APPEAL SUMMARY

Appeal ID: 20703	Project Address: 2141 NW Davis St
Hearing Date: 8/7/19	Appellant Name: Anne Marie Kuban
Case No.: B-004	Appellant Phone: 5032359400
Appeal Type: Building	Plans Examiner/Inspector: Steve Mortensen, Joe Thornton
Project Type: lur	Stories: 7 Occupancy: R-2, B, S-1, S-2 Construction Type: I-A
Building/Business Name: 705 Davis Condominiums	Fire Sprinklers: No
Appeal Involves: Alteration of an existing structure, other: Building Occupancy During Construction	LUR or Permit Application No.: 19-132181-CO
Plan Submitted Option: pdf [File 1] [File 2]	Proposed use: Residential

705 DAVIS CONDOMINIUM BALCONY IMPROVEMENTS

EGRESS OF BUILDING DURING CONSTRUCTION DIAGRAMS

SITE / BASEMENT (EXISTING CONDITION) 4

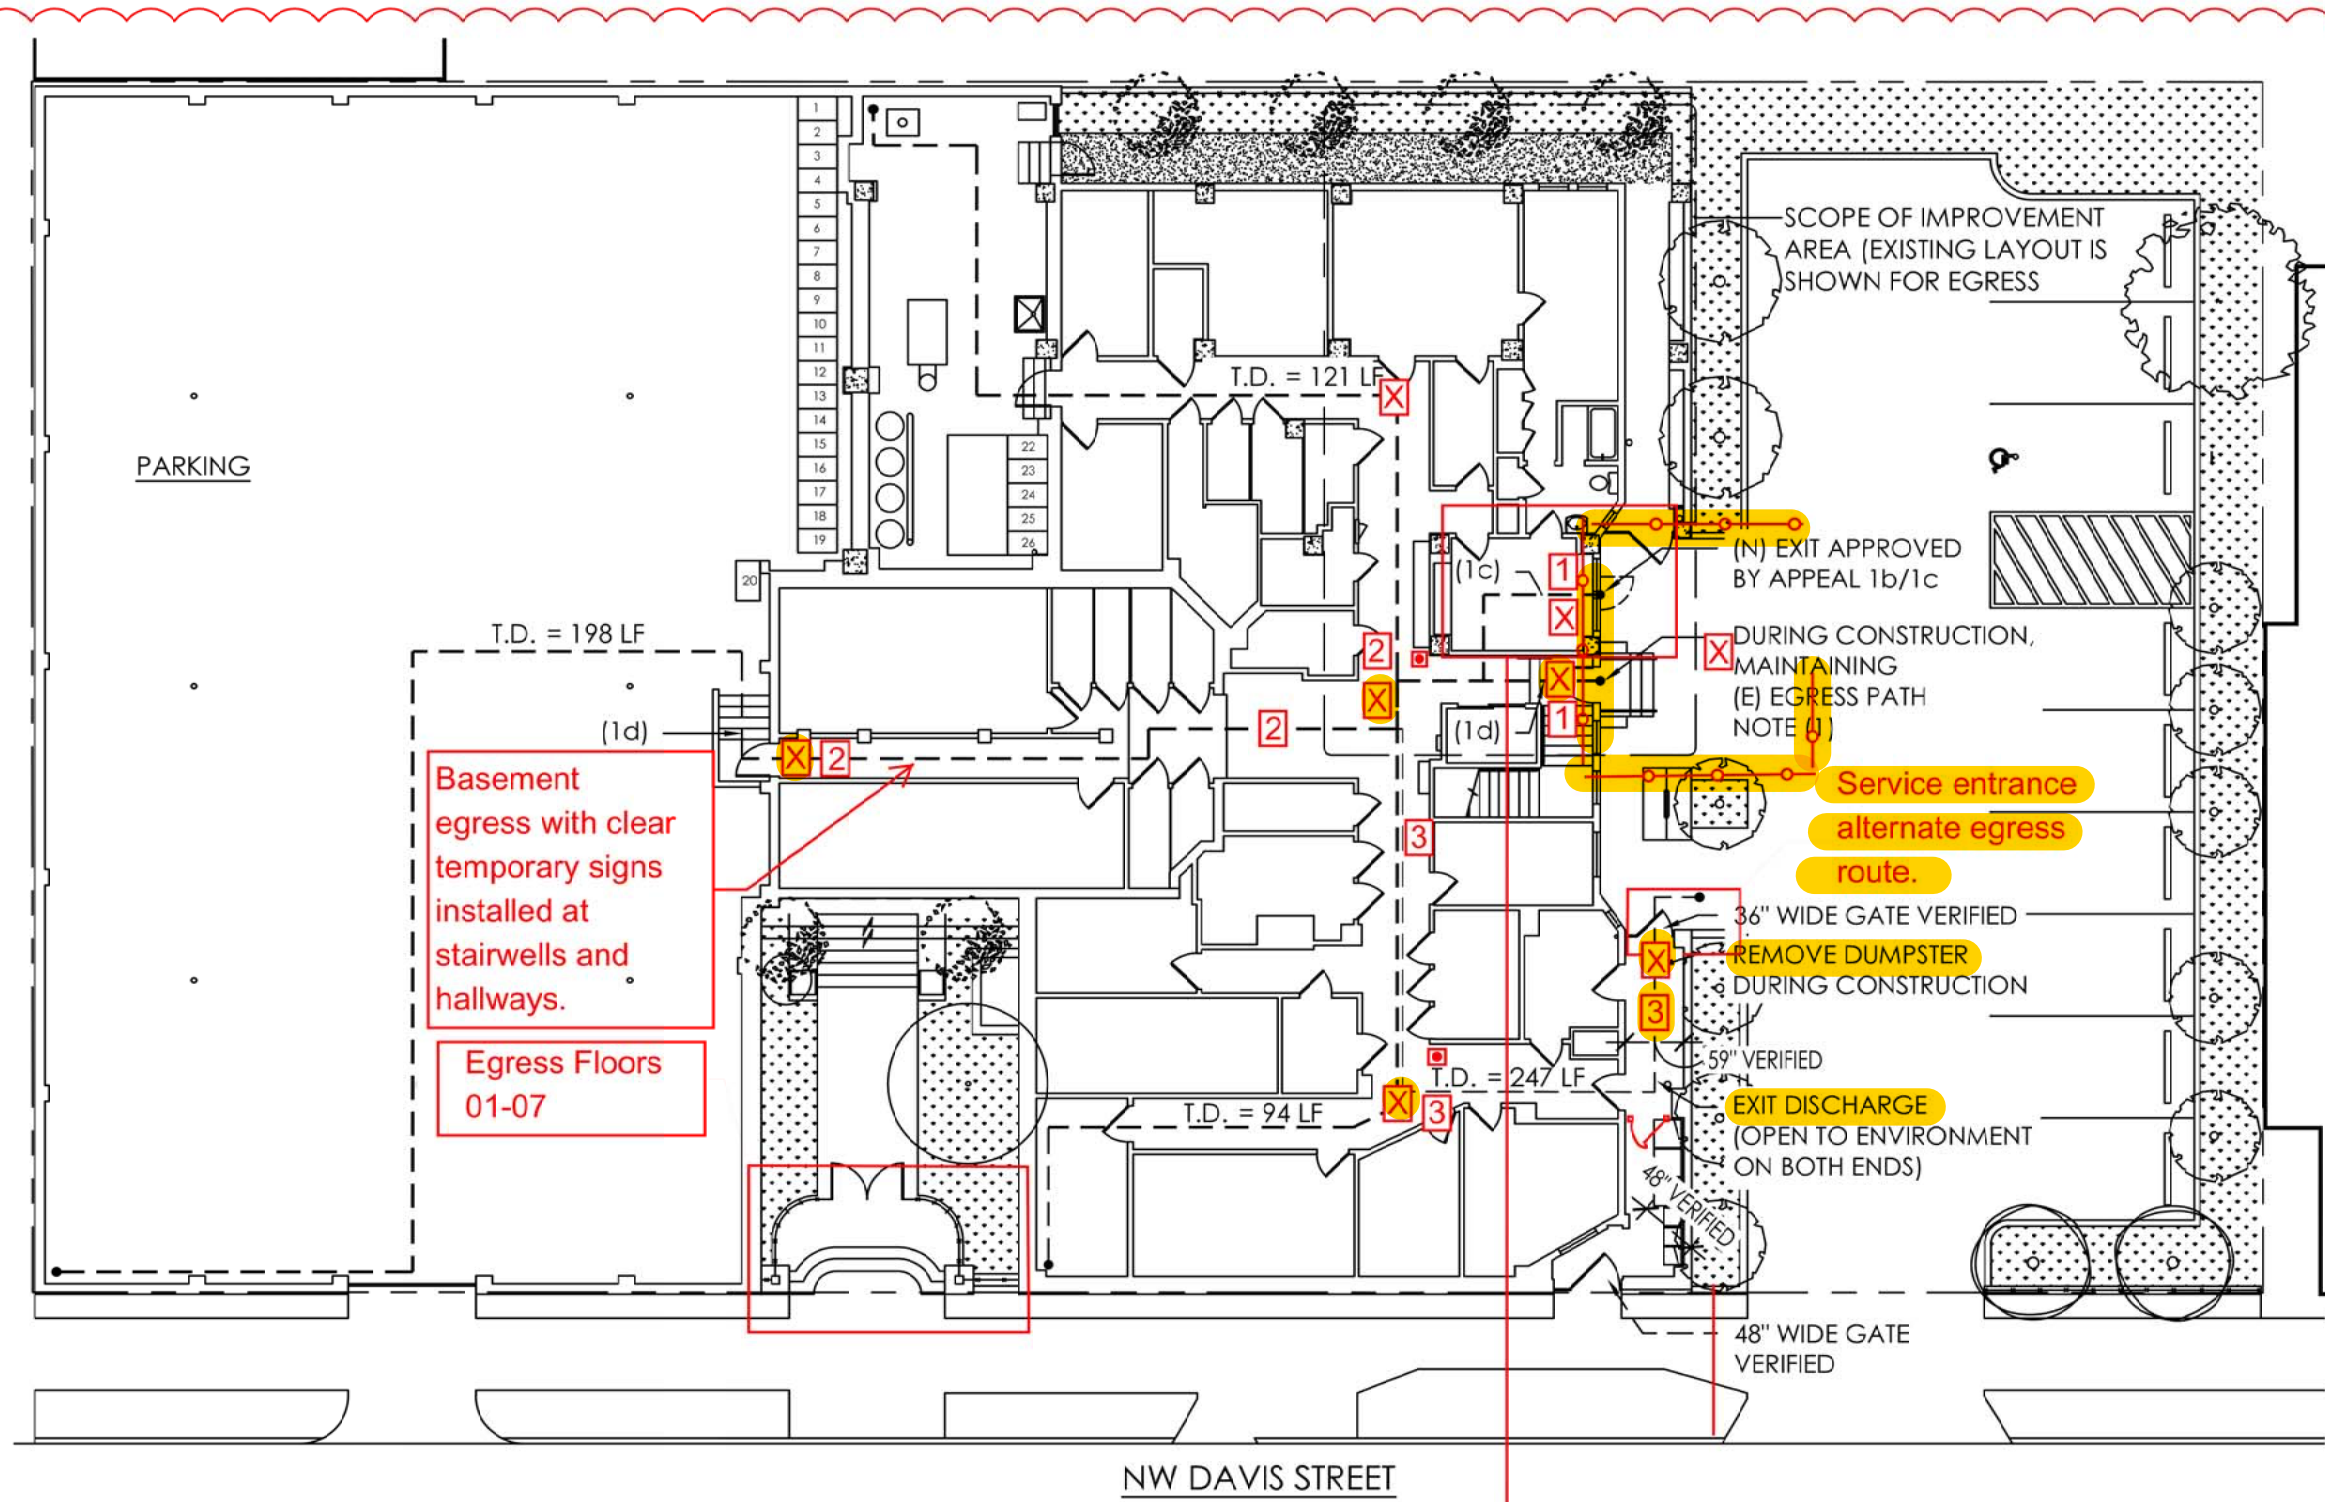
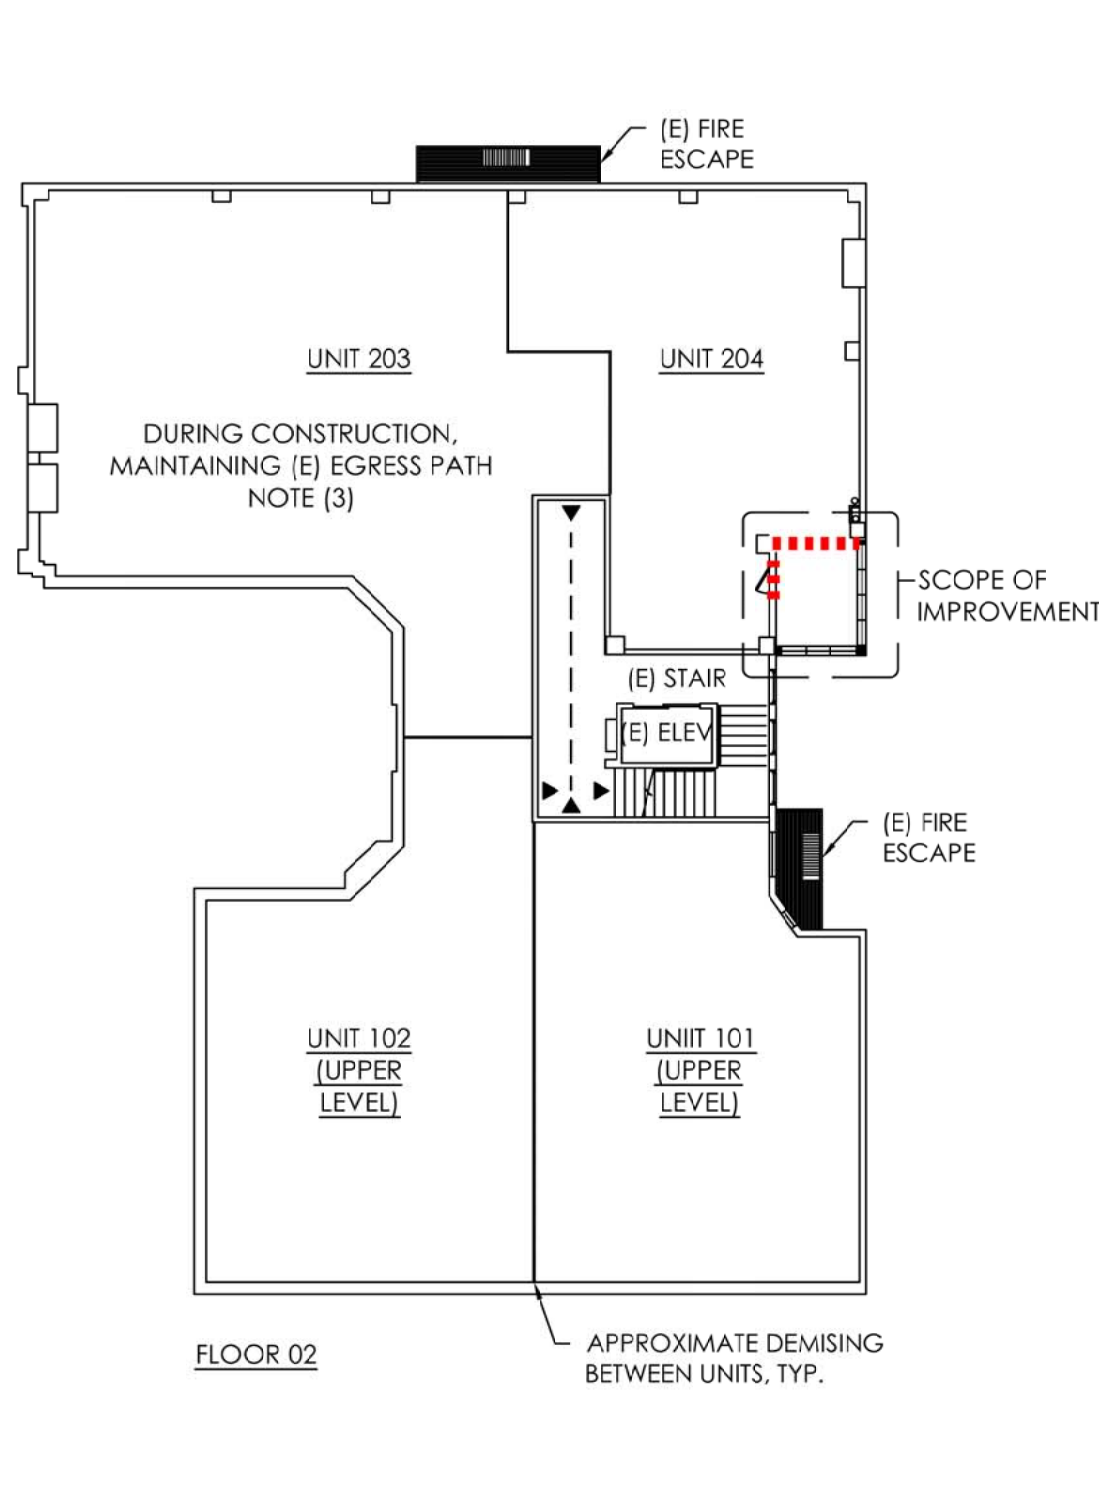
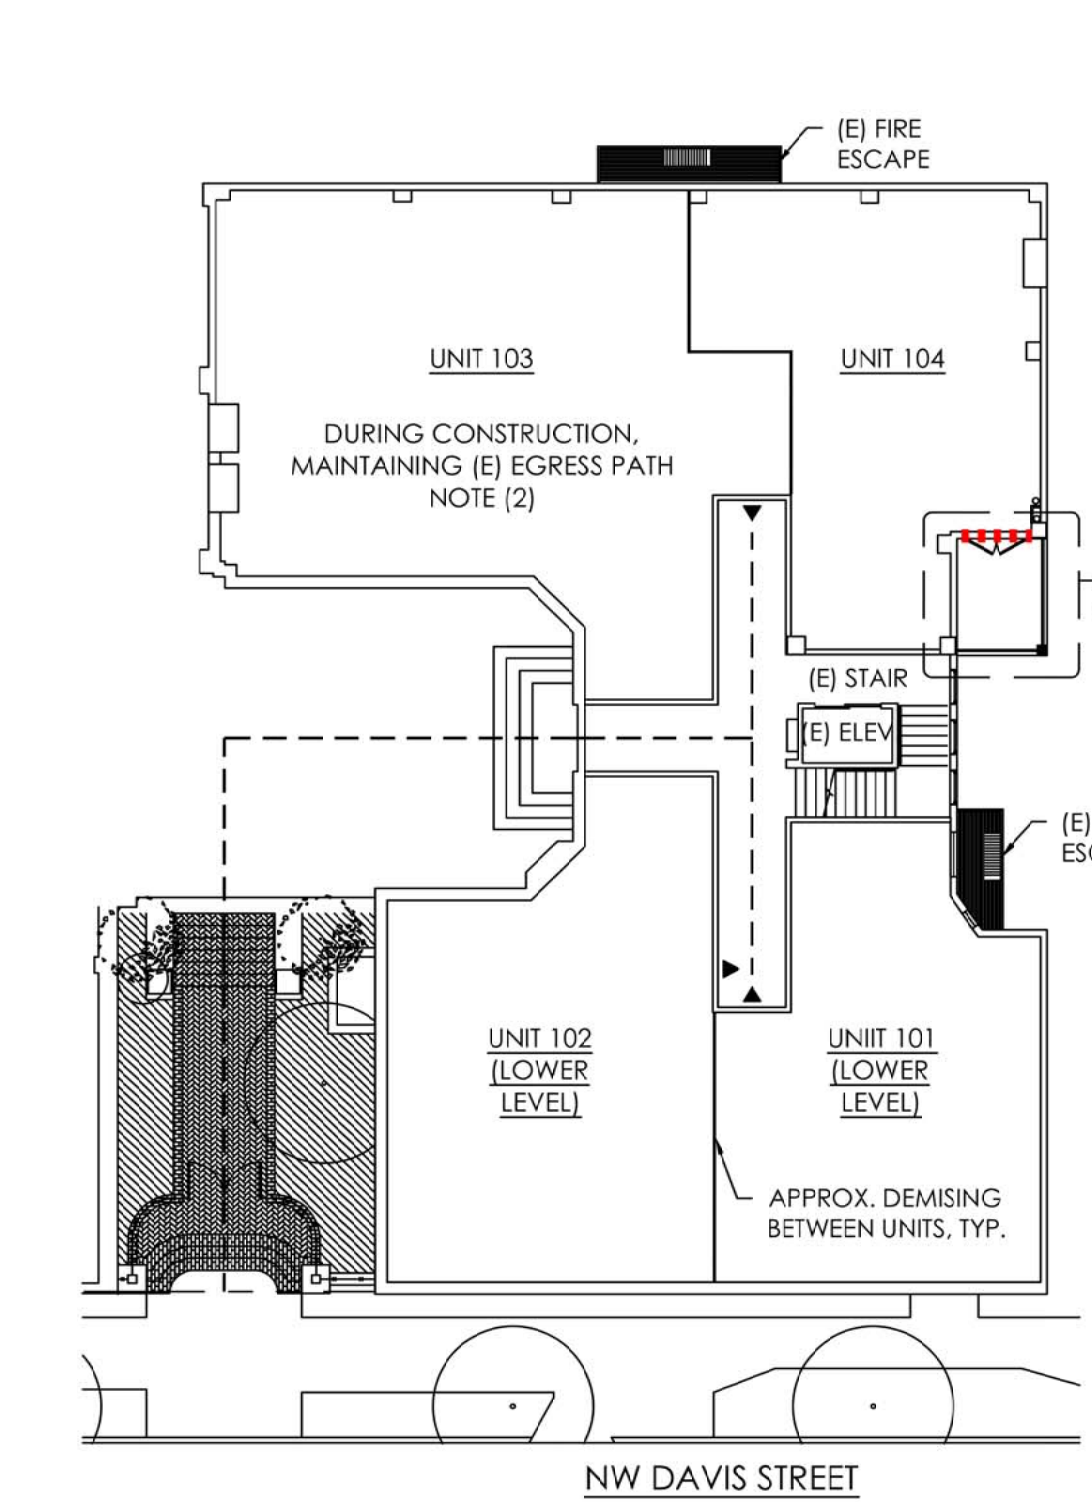
Code Section	3302.1, Engineering Guide # 1 Occupancy of Buildings During Construction OSSC Table 1016.2
Requires	Please see Plancheck item from Steve Mortensen -- Item 12b as included in the pdf attachments to this Appeal. In summary, Steve Mortensen is requiring that during construction only, if we change the approved, existing egress route of the building (Chapter 13 Building) in any way—especially through a service entrance—the project would need approval by Appeal.
Proposed Design	<p>Existing egress from the floors 01-07, (residential use) will not change from the approved egress system -- exiting from the ground floor to an exterior exit courtyard leading to the public way. Changes to the egress system were approved under Appeal #20301 Items 2a and 2b.</p> <p>For the basement -- during construction only -- the General Contractor is striving to maintain the existing egress system through the area of alterations, and they are providing a tunnel under the exterior scaffolding to the exterior parking lot leading to the public way. This item will be planchecked and have not been included in the documentation.</p> <p>However, we understand due to the project's parameters the existing egress route may not be always available.</p> <p>As a response to this issue, we are proposing a second, alternate means of egress through an existing service area. Please see attached plan G1.2. This egress path egresses through a former trash area to the exterior parking lot and public way.</p> <p>The building is non-sprinklered.</p> <p>The building has a dry stanpipe with residential type fire hose at each floor.</p> <p>The building has a fire alarm system.</p>

- a. The alternate path extends the travel distance from the parking garage from 198 LF to 247 LF.
- b. The alternate path extends the travel distance from the mechanical room from 121 LF to 167 LF.
- c. The trash provisions will be removed in this area and a barricade will be installed to limit access to the reduced trash area.
- d. The path through this area has been verified at 59" wide with a 36" wide gate—egressing a total maximum occupancy of 53 occupants during construction.
- e. This basement level service area open to the exterior on both ends.

We are seeking approval of this alternate egress path on a temporary basis, with inspectors' and tenant notification, as to exact time where the existing egress system cannot be used.

12	All	3302.1, Engineering Guide # 1	<p><u>Occupancy of Buildings During Construction:</u></p> <p>Because the existing building appears to be fully occupied during construction of the work in this permit, please provide dedicated occupancy safety plans for each floor and an occupancy safety narrative on the drawings to demonstrate how occupants will be protected (from dust, where existing guardrails are removed, etc.), egress will remain unobstructed and life safety and structural systems will be continuously functioning during all phases of construction. I've attached a pdf of the City of Portland's "Engineering Guide #1" to the email containing this check sheet for reference. See also OSSC 3202.1.</p> <p>Recheck 01: This item has not been adequately addressed.</p> <ol style="list-style-type: none"> Please include the occupancy safety plans and narrative on the architectural permit drawings as previously requested. It is not acceptable to provide this information on a separate document. Recheck 02: Resolved. The occupancy safety narrative indicates egress through the basement lobby will be closed during construction, and that all building egress will be routed through the main lobby, presumably at the main floor. Because the exit access travel distance per OSSC Table 1016.2 and the common path of egress travel distance per Table 1014.3 are being increased from the basement spaces, and because the common path of egress travel distance from the basement spaces is already non-compliant with OSSC Table

<p>1014.3 (75 feet max), approval must be requested for the proposed egress approach during construction through the building code appeal process. Complete egress plans showing the entire basement and first floors, with the full length of exit access travel distance shown from the most remote point of the S-2 parking garage, and the most remote point of the S-1 basement storage area, to the exterior of the building at the first floor, should be included in this appeal. Please note, I can't guarantee any building code appeal will be granted.</p> <p>Recheck 02: Thank you for providing the occupancy safety plans on sheet G1.2. Proposed egress from the basement during construction has been revised to continue to use the existing east basement entry door and a scaffolding tunnel, in lieu of routing basement occupants up the stair to the main lobby and building exterior at the next floor up.</p> <p>Please note, as discussed with the structural reviewer, the scaffolding tunnel will need to be reviewed by the structural reviewer and the fire reviewer, so please contact them directly with any questions regarding their review criteria or what they need to see on the drawings.</p> <p>The JR Johnson letter on sheet G1.2 and the notes in red below the basement occupancy safety plan indicate that egress through this existing basement door will be restricted from 8am to 5pm during construction which is not permitted. Per OSSC 3302.1, required egress must be maintained unobstructed <u>at all times</u> during construction. Egress cannot be restricted or blocked from 8am-5pm or at any other time.</p> <p>The JR Johnson letter on sheet G1.2 and notes in red on the basement occupancy safety plan indicate that temporary signage and temporary walls will be provided to direct occupants and provide unobstructed egress. However, the temporary signage and walls have not been shown on the occupancy safety plans. Please update sheet G1.2 to show these elements where they will occur to demonstrate compliance with the applicable requirements of OSSC Chapter 10.</p> <p>An alternate basement egress path is shown passing through the service entrance at the southeast corner of the basement, presumably for use while the egress path through the existing basement door noted above is blocked. However, the service entrance area appears to be used for storage of trash containers, which means it is a storage room. Egress cannot pass through storage rooms per OSSC 1014.2 Item 4. In addition, the width of the egress path through this area is less than 3 feet wide in some places, which is not permitted. Per OSSC Table 1018.2, the egress path must be minimum 36" wide where occupant load is less than 50.</p> <p>Even if the service entrance is revised to be a corridor during construction, with the trash containers removed and notes added to</p>

<p>indicate that no storage will occur in this space during construction, a building code appeal will still be required to request approval for this proposed design because it is a change to the egress path of a Chapter 13 building.</p> <p>It may be possible to request approval for the proposed occupancy safety plan through the building code appeal process. However, please note that I can't guarantee any building code appeal will be granted.</p> <p>c. Please show how on the drawings how access will be blocked to the floor areas being added to each floor.</p> <p>Recheck 02: Resolved.</p>
13	A2.1	ICC A117.1 as noted	<p><u>Accessibility:</u> Please dimension the accessible maneuvering clearance at the latch jamb on both sides of doors 001 and 005 on enlarged plan 2/A2.1 per the applicable diagram in ICC A117.1 Figure 404.2.3.2.</p> <p>Recheck 01: Resolved.</p>
14	G0.0, A9.2, A9.4	OEESC as noted	<p><u>Energy:</u></p> <ol style="list-style-type: none"> Per OEESC 101.4.2, additions must comply with the current OEESC. Per OEESC Table 502.1.1, metal framed walls above grade must be insulated with R-13 + R-7.5 continuous insulation. The R-21 insulation shown in the stud space of the exterior details on sheets A9.2 and A9.4 is not permitted. Please revise the exterior details to provide min R-13 + R-7.5 continuous insulation. If foam plastic insulation will be used as the continuous insulation, provide information on the drawings to demonstrate compliance with OSSC 2603.4 and 2603.5 thru 2603.5.7, including the NFPA 285 tested assembly required by OSSC 2603.5.5. Note that an NFPA 285 test is an assembly test, not a material test, so the entire assembly must comply. Recheck 01: Resolved. Please indicate the R-factor of the roof insulation in detail 6/A9.2 to be R-38 per OEESC Table 502.1.1. Recheck 01: Resolved. Please indicate the R-factor of the floor insulation in detail 5/A9.2 to be R-30 per OEESC Table 502.1.1. Recheck 01: Resolved. Please indicate the U-factors and SHGC for the new windows and exterior doors on the drawings on the drawings to be the applicable value from OEESC Table 502.3. Recheck 01: Resolved.

Chapter 13 building to remain occupied during construction: Granted provided the egress path remains unobstructed and is a minimum of 44 inches wide.
